Subject: 10CFR21 Reporting of Defects and Non-Compliance -
Engine Systems, Inc. Report No. 10CFR21-0077
Graham-White Air Start Solenoid Valves #712-015 & #712-065

Report No. 10CFR21-0077
January, 22, 1998

10CFR21 REPORTING OF DEFECTS AND NON-COMPLIANCE

COMPONENT: Graham-White Air Start Solenoid Valves #712-065 & #712-015

GRAHAM-WHITE DRAWING 712-015

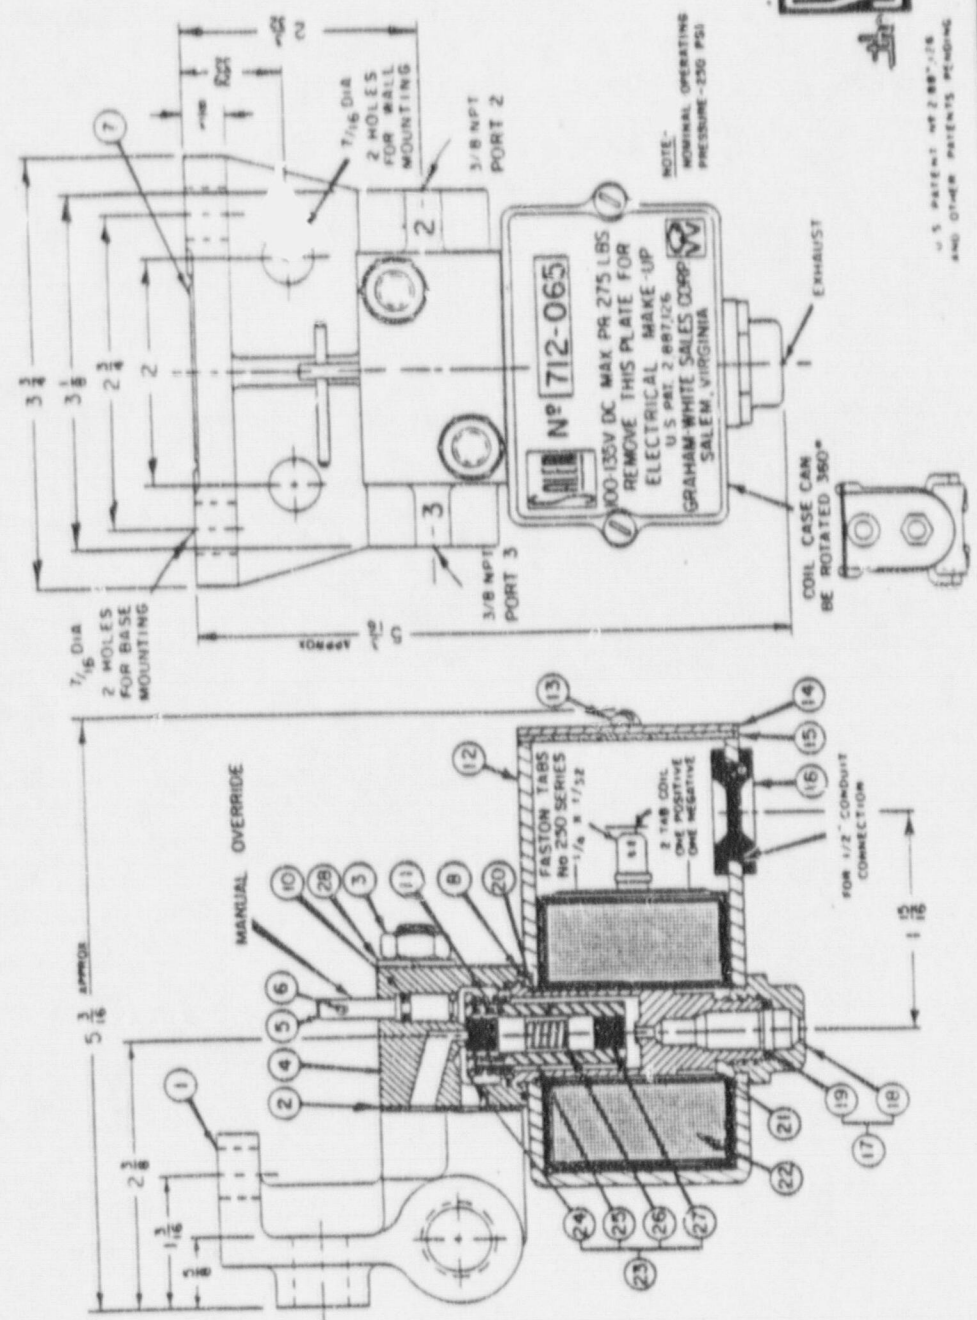
Engine Systems, Inc (ESI) has recently learned that the 275 psig valve does not meet the minimum DC voltage requirement of most nuclear applications when inlet pressures below 200 psig are applied to the valve. The solenoid valve relies on system air pressure to assist the coil in overcoming the force of the spring and thus operating the valve plunger. The reduced system pressure combined with the reduced coil voltage results in the inability of the valve to operate satisfactorily. This problem is not applicable to the original 200 psig valve because it has a weaker spring and therefore less air pressure is needed to overcome the lower spring force.

The valve does not meet the minimum DC voltage requirement of most nuclear applications (usually 90 VDC or 105 VDC is specified) when inlet pressures below 200 psig are applied to the valve. The solenoid valve relies on system air pressure to assist the coil in overcoming the force of the spring and thus operating the valve plunger (see valve literature contained in

Exhibit 2). For the EMD engine, 200 psig is the maximum allowable inlet pressure for the on-skid air start manifold piping and air starting motors. Minimum allowable starting pressure is 125 psig to 150 psig, depending upon the specific design of the diesel generator. To meet this criteria for all applications, the air solenoid valve must operate satisfactorily at 125 psig with 90 VDC applied to the coil. ESI tested three valves with the 275 psig springs. The following results were achieved:

A. If the site minimum voltage is below 105 VDC, replace the valve's spring or replace the entire valve assembly. ESI consulted with Graham-White's spring supplier and obtained valve springs designed for 230 psig maximum inlet pressure. Eight (8) solenoid valves with the 230 psig springs installed were tested by ESI. Air valves operated satisfactorily at 100 psig with 90 VDC applied to the coils. In addition, the valves did not experience leakage with inlet pressures up to 230 psig.

Use the procedure contained in Exhibit 3. Replace the 275 psig spring with a 230 psig spring. Spring information is provided below.

<u>Spring</u>	<u>Color</u>	<u>Part Number</u>	<u>Comments</u>
275 psig	Red	#1508-003	Recommended by 10CFR21-0055.
230 psig	Blue	#1508-002(6.54#)	Recommended by this notification.
200 psig	Silver	#1508-001	Originally provided by EMD.
